Tubridgi gas field development

Doral Resources NL

**Report and recommendations
of the
Environmental Protection Authority**

**Environmental Protection Authority
Bulletin No. 446
September 1990**

Figure 2: Layout of wells and processing facilities

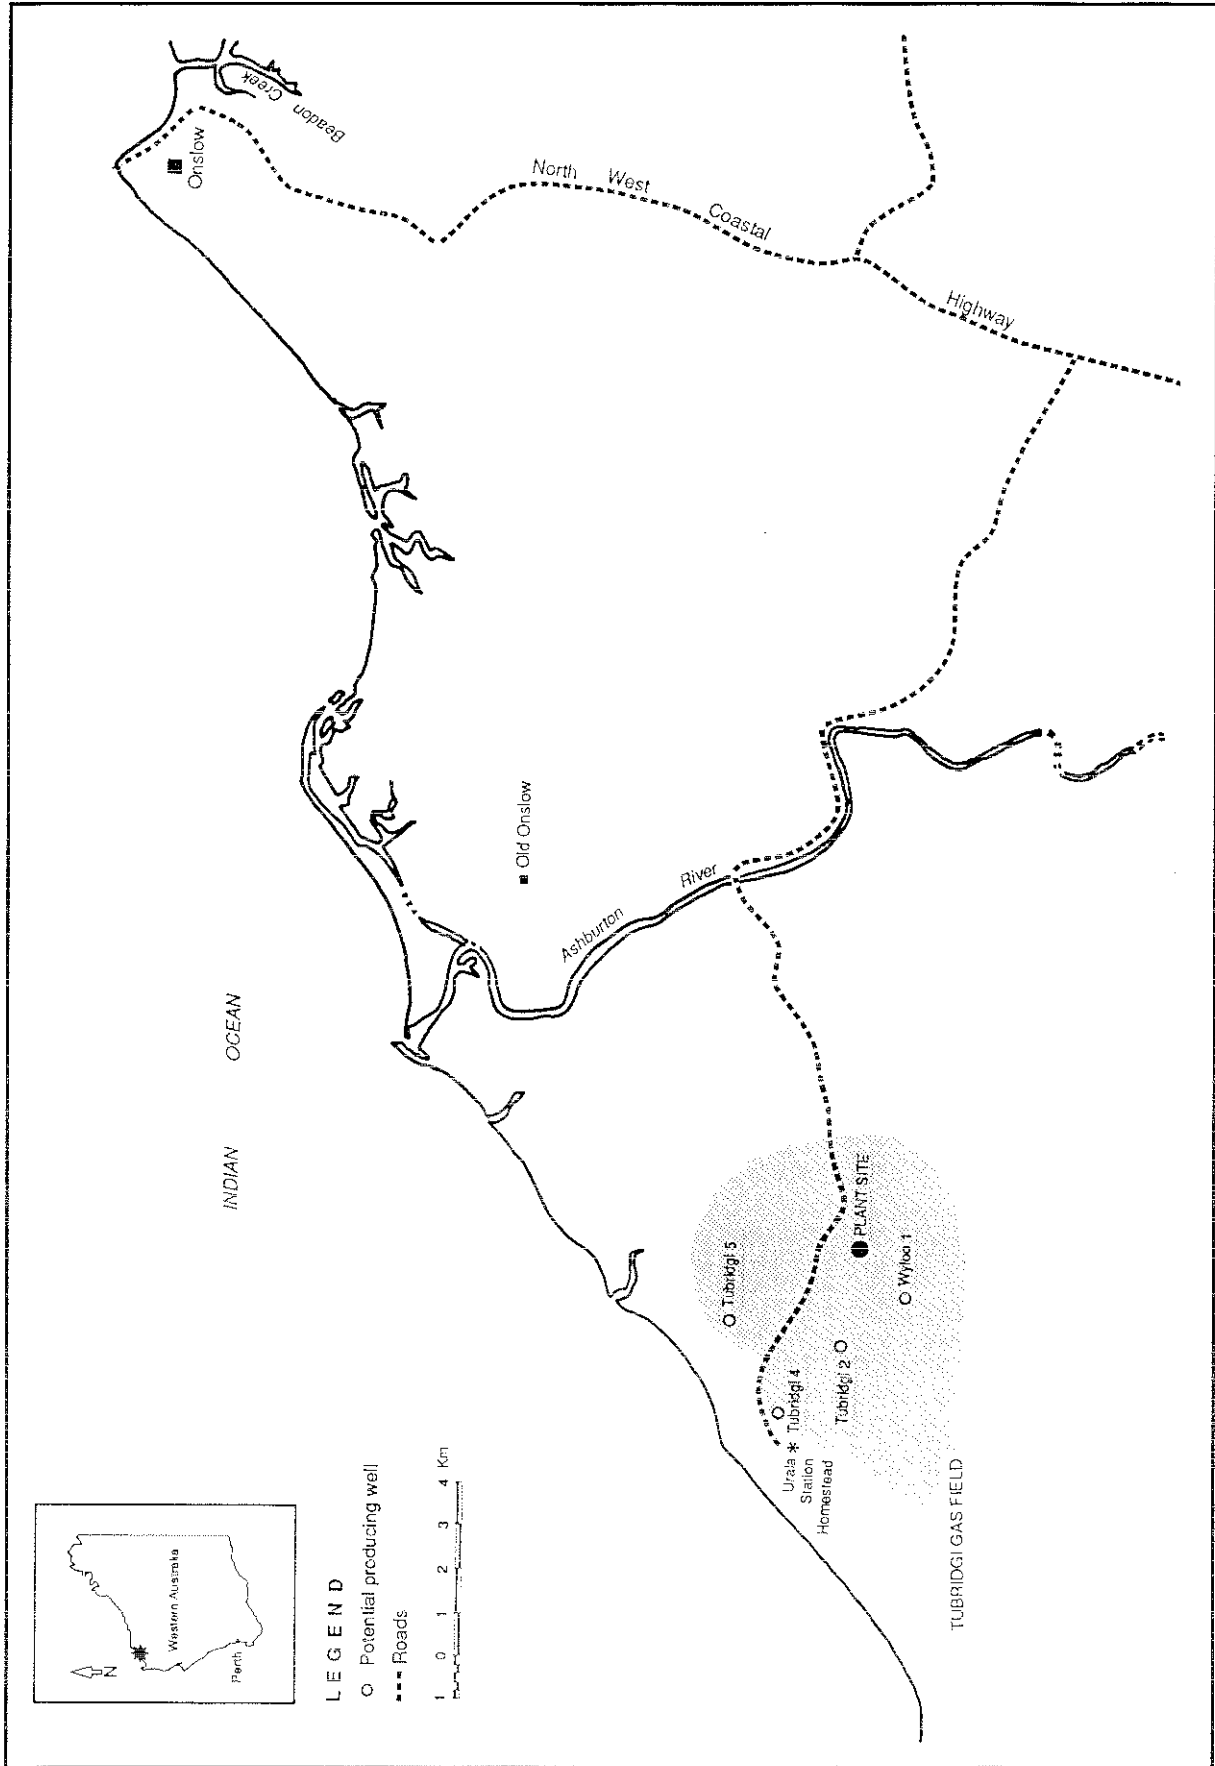
Gas would flow in buried lines to a central treatment plant (see Figure 2) where it would be cleaned and compressed. It would then flow down a buried 150 mm to 200 mm diameter pipe to compressor station CS2 on the existing gas pipeline to Perth. The route has been chosen to avoid archaeological sites and the easement width would be kept to the minimum to reduce environmental impacts. After construction the pipeline route would be rehabilitated and regularly inspected.
